SHOP DRAWING / SUBMITTAL REVIEW

SCOPE OF THIS WORK
PROVIDE WIND PRESSURE CALCULATIONS FOR THE DOOR
AND WINDOWS ON THIS PROJECT.

THE DYLAN & JAMIE
ROY FAMILY
WIND PRESSURE FOR
WINDOWS
6783 SW 104TH ST.
PINECREST FLORIDA

S-1

PARTIAL FLOOR PLAN
SCALE: 1/4" = 1'-0"

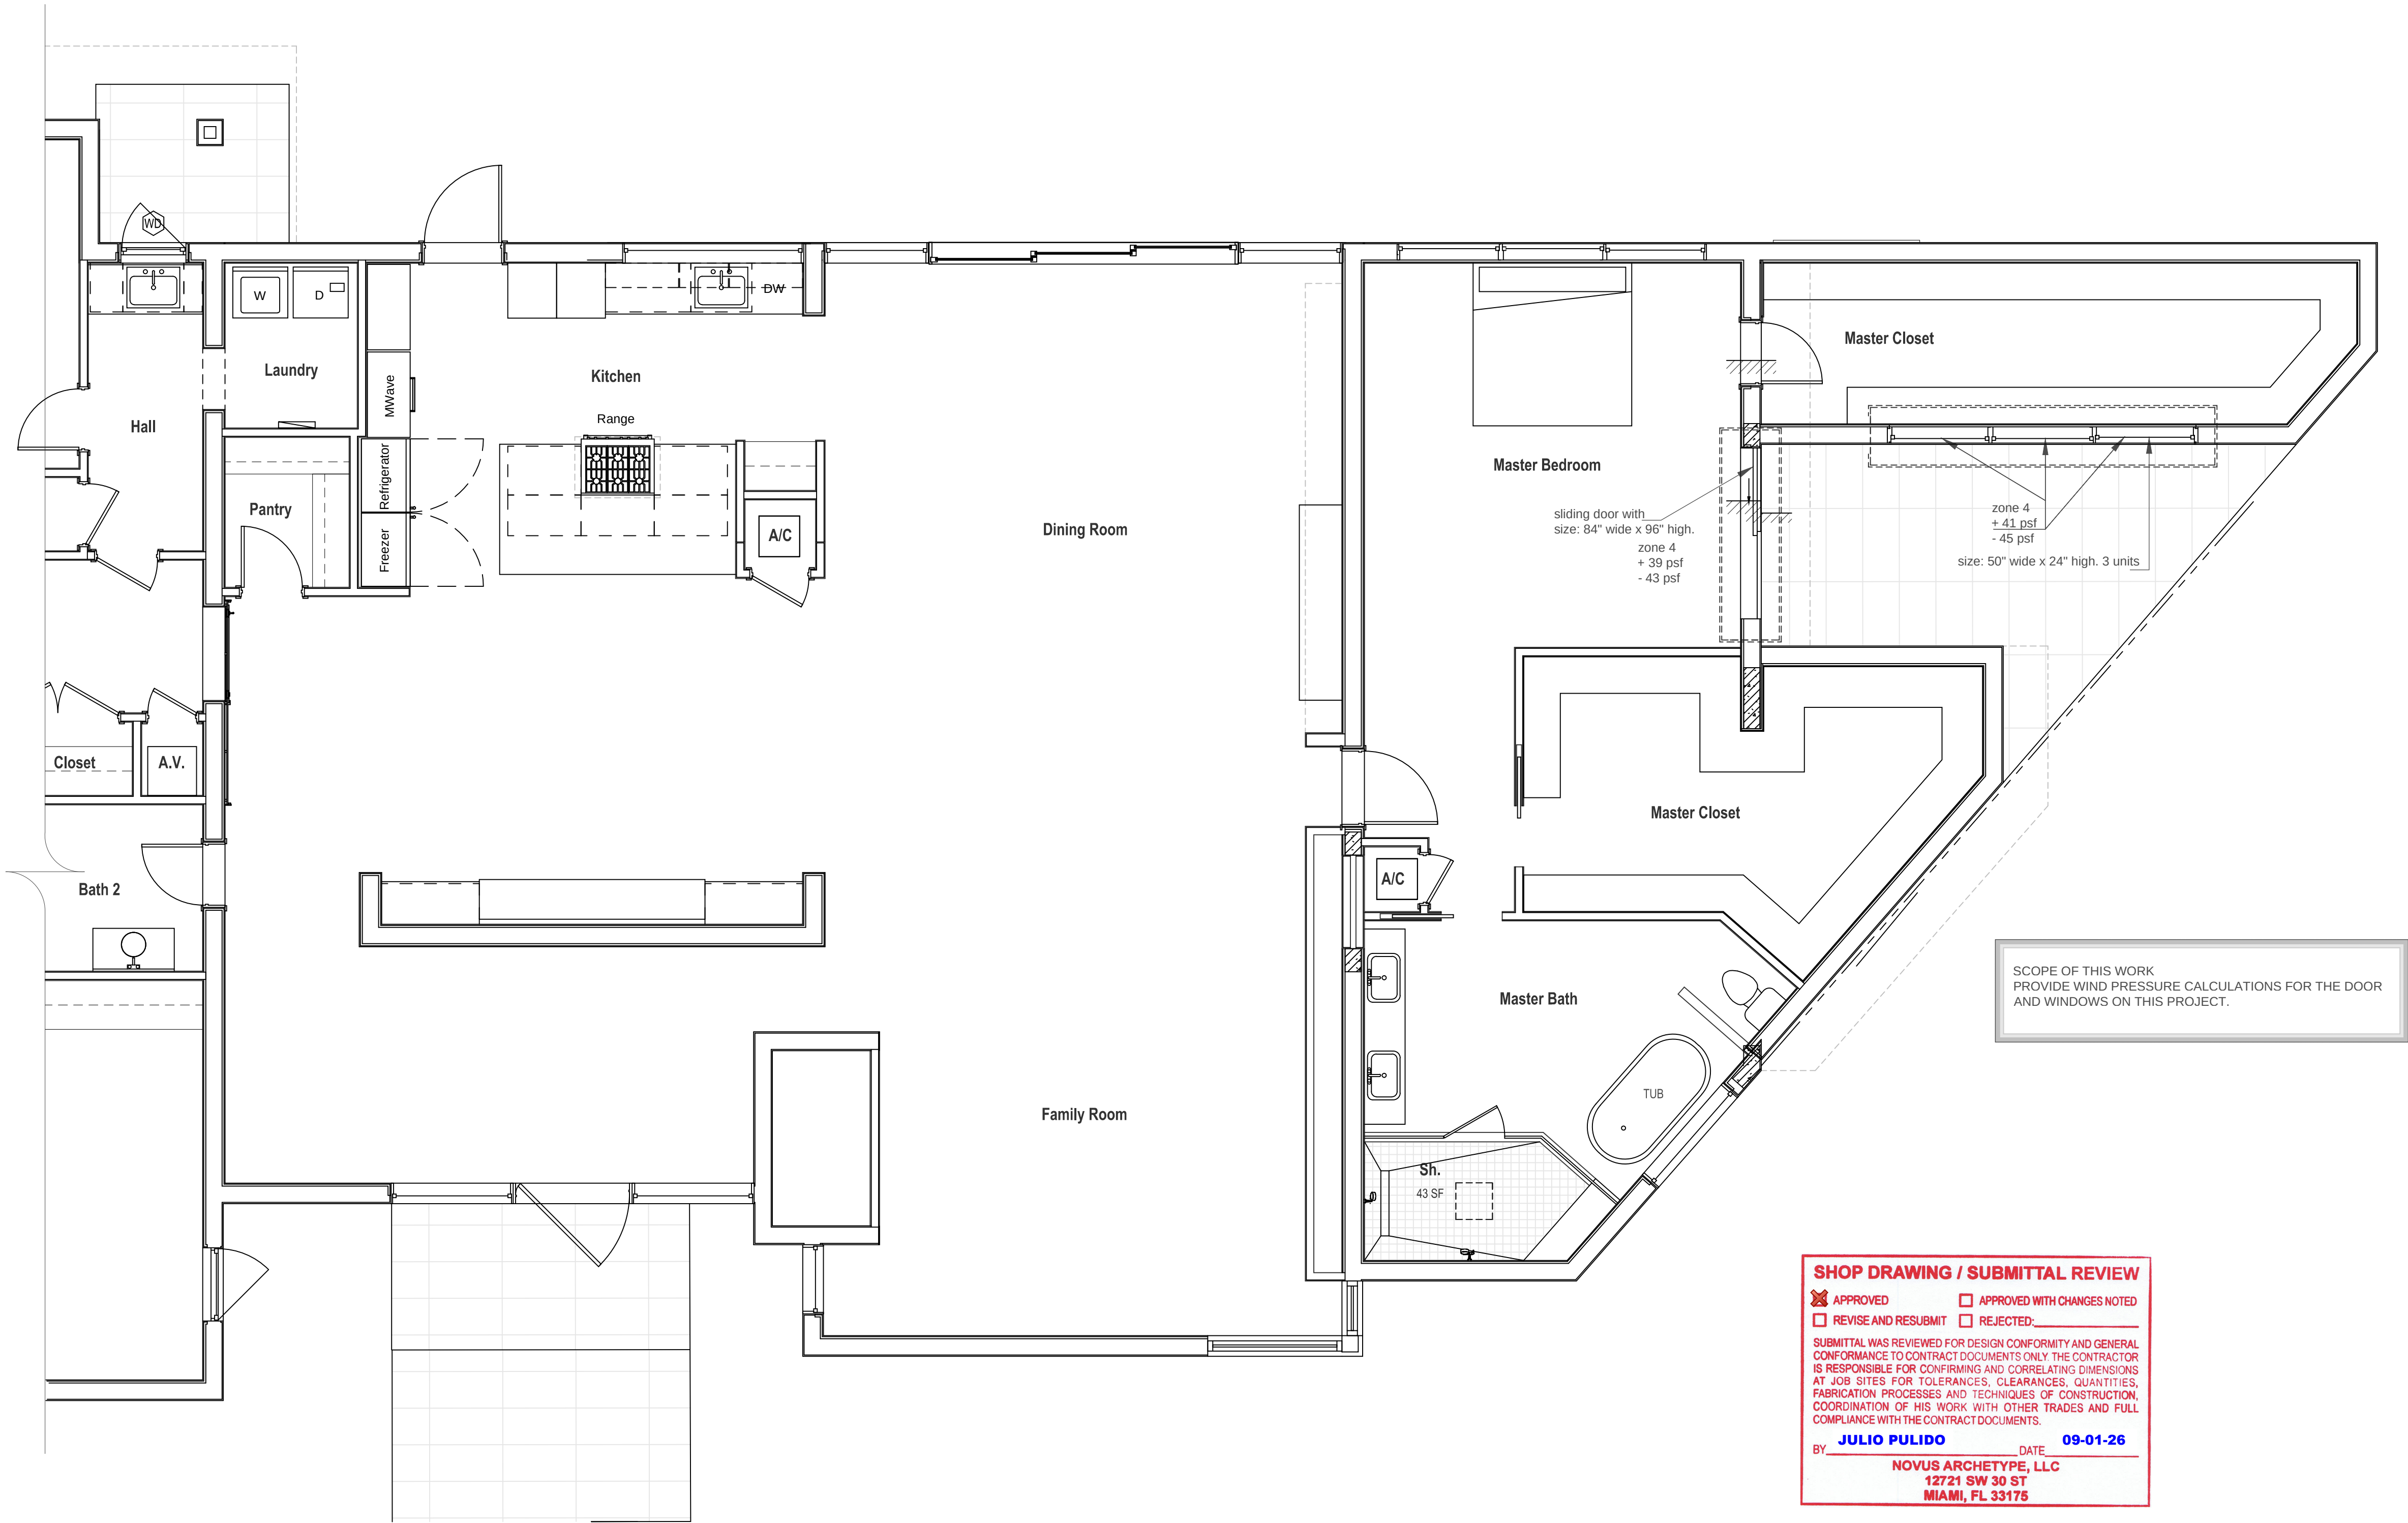
☒ APPROVED	☐ APPROVED WITH CHANGES NOTED
☐ REVISE AND RESUBMIT	☐ REJECTED

SUBMITTAL WAS REVIEWED FOR DESIGN CONFORMITY AND GENERAL CONFORMANCE TO CONTRACT DOCUMENTS ONLY. THE CONTRACTOR IS RESPONSIBLE FOR CONFIRMING AND CORRELATING DIMENSIONS AT JOB SITES FOR TOLERANCES, CLEARANCES, QUANTITIES, FABRICATION PROCESSES AND TECHNIQUES OF CONSTRUCTION, COORDINATION OF HIS WORK WITH OTHER TRADES AND FULL COMPLIANCE WITH THE CONTRACT DOCUMENTS.
